Pamela Abee-Taulli
Environmental Program
Coordinator
Development Services
Department

**BLUERIDGE MULTIFAMILY AT
WILDHORSE RANCH**

**9825 WILDHORSE RANCH
TRL
SP-2022-0426C.SH**

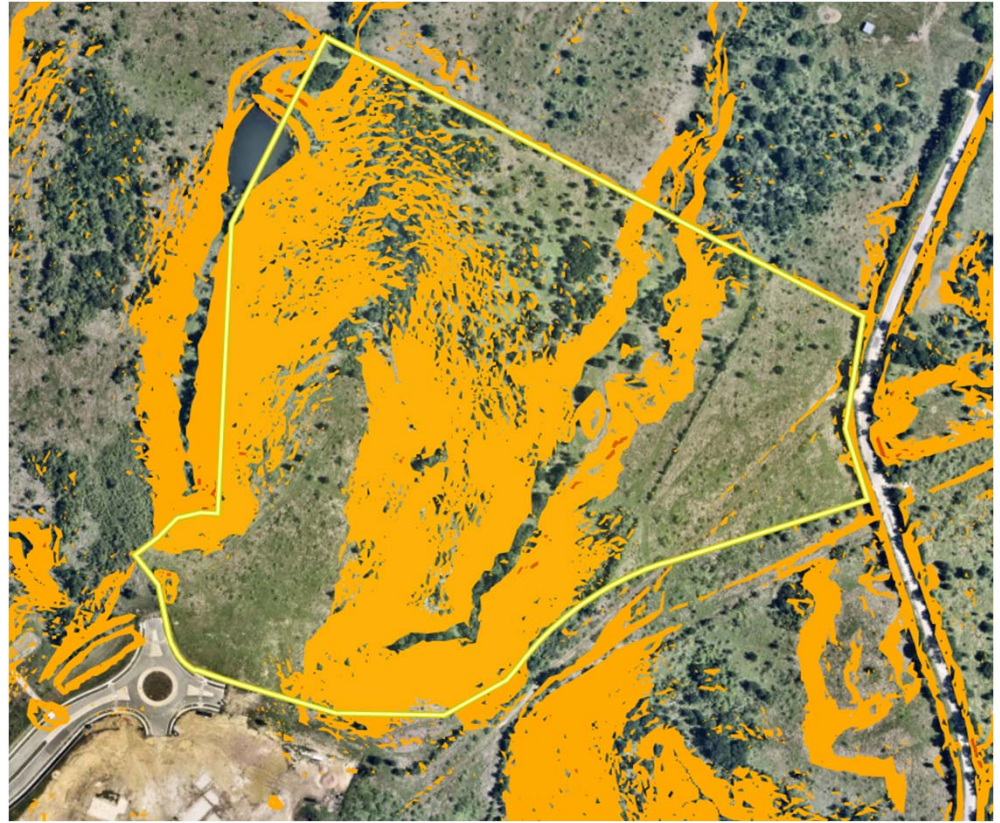
50% has slopes over 15%

- Multi-family, residential
- Layout concentrates development in the 0-15% slope areas.

THE DEVELOPMENT

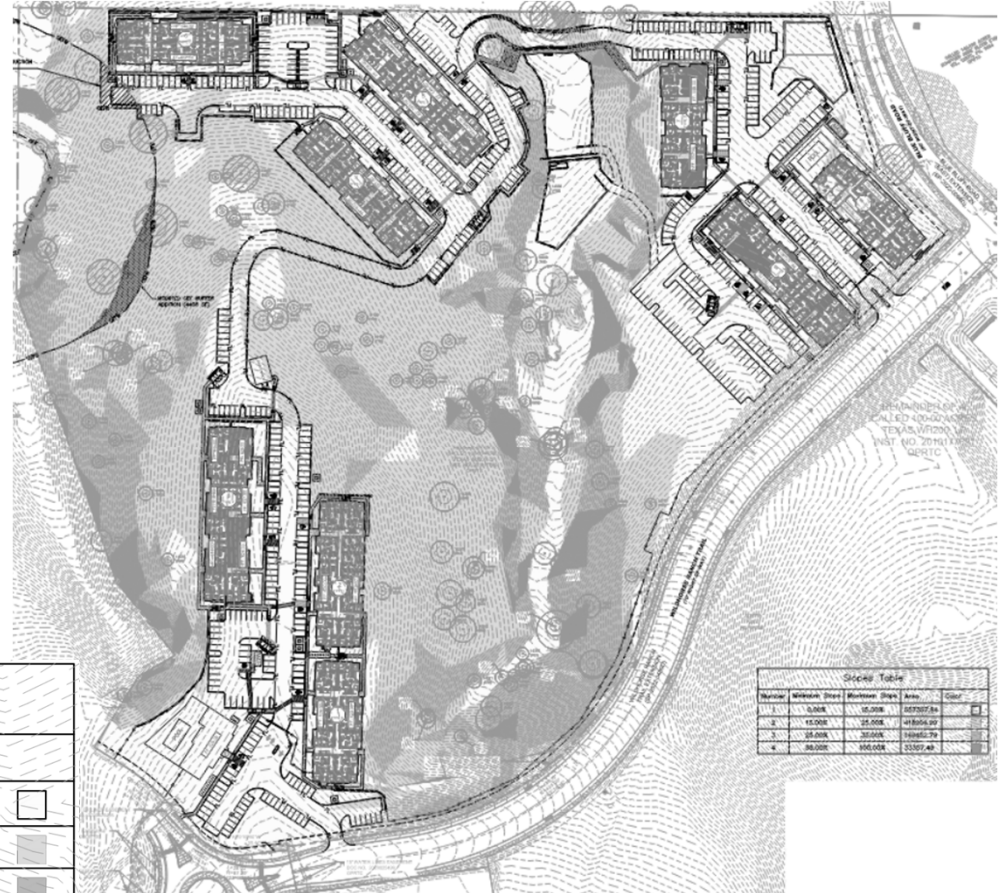
- The initial design did not propose grading over 8 feet.
- The revised, ADA compliant plan has minimal grading over 8 feet.

When the project was changed to be a SMART Housing project, the grading had to be redesigned to meet ADA requirements.

1. The variance request is to allow cut over 4 feet to 12 feet.

2. The variance request is to allow fill over 4 feet to 10 feet.

Staff recommends the variances, with the following conditions.

1. Water quality to be provided with biofiltration ponds instead of the standard sand-bed ponds.
2. Containment of fill with walls or terracing.
3. Revegetation of cuts with native seeding and planting (see Standard Specifications Manual 609S.5)
